0CAN090901

Subject: Generic Letter 2004-02 Final Supplemental Response  
Request for Additional Information  
Arkansas Nuclear One – Units 1 and 2  
Docket Nos. 50-313 and 50-368  
License Nos. DPR-51 and NPF-6

**Attachment 1 to  
0CAN090901  
ANO-1 RAI Responses**

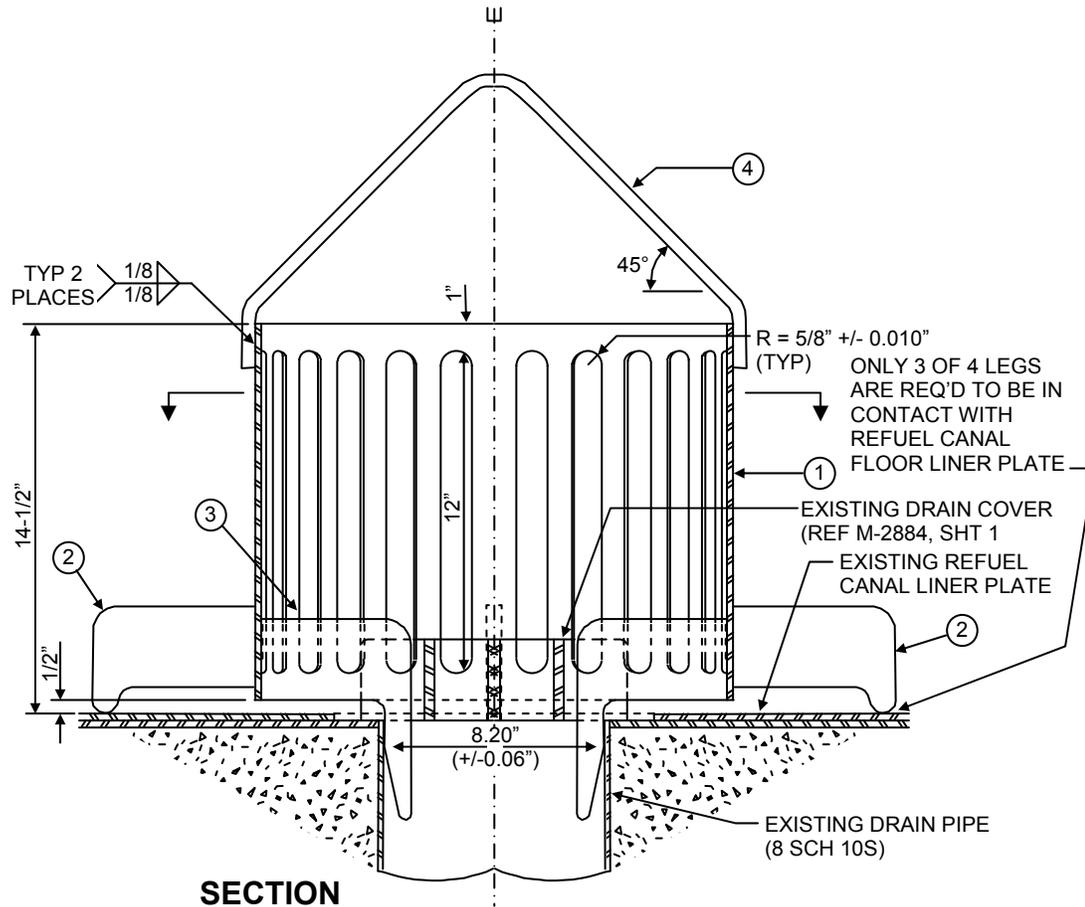
**B16. Your letter dated September 15, 2008, states that a larger drain cover will be placed over the refueling canal drain. Please describe the size of this cover, the size of the openings in the cover, and state whether it has a raised design or other features that would prevent debris blockage. Also, please discuss the types of debris that could be blown into the upper containment and potentially reach the refueling canal drains, including large pieces of insulation, smaller pieces of insulation, and other types of debris (e.g., miscellaneous debris). In addition, please discuss the potential for sheeting flow in the refueling canal and for temporary floatation and transport of debris over the drain due to refueling canal drain surface currents, absorption of water into the material, and subsequent sinking of the material to cover the drains. In light of the considerations above, please provide the basis for concluding that the refueling canal drain would not become blocked by post-LOCA debris.**

As noted in final supplemental response dated September 15, 2008, Section 3.1.4 the refueling canal drain strainers installed are made from 18" diameter pipe and are 14-1/2" in height. A diagram is provided below. The strainers include 24 slots measuring 1-1/4" wide by 12" long in the sides to allow water flow while avoiding the risk of blockage.

Debris blockage of the ANO-2 refueling canal deep-end drains is not considered credible following a primary system pipe break that requires sump recirculation. The vast majority of surface area of RCS piping that could result in such an event is located in the two SG cavities. A significant amount of debris could potentially be created by such a high energy pipe rupture; however, very little of this debris would be expected to exit the top of the SG cavities. The larger RCS pipes, hot leg and cold leg, are located in the lower elevations of the SG cavities, with the hot leg and two cold leg penetrations from the reactor cavity entering at approximately elevation 371' and the cold legs extending down to 364.7' elevation. The SG compartment includes grating platforms covering portions of the cavity above these elevations at 375', 387', 405' and 413', as well as having a grating cover on top of the SG cavity at elevation 426'. In addition to grating there are numerous other barriers such as the reactor coolant pumps, seismic restraints, and structural steel beams (and the pressurizer compartment in the south cavity).
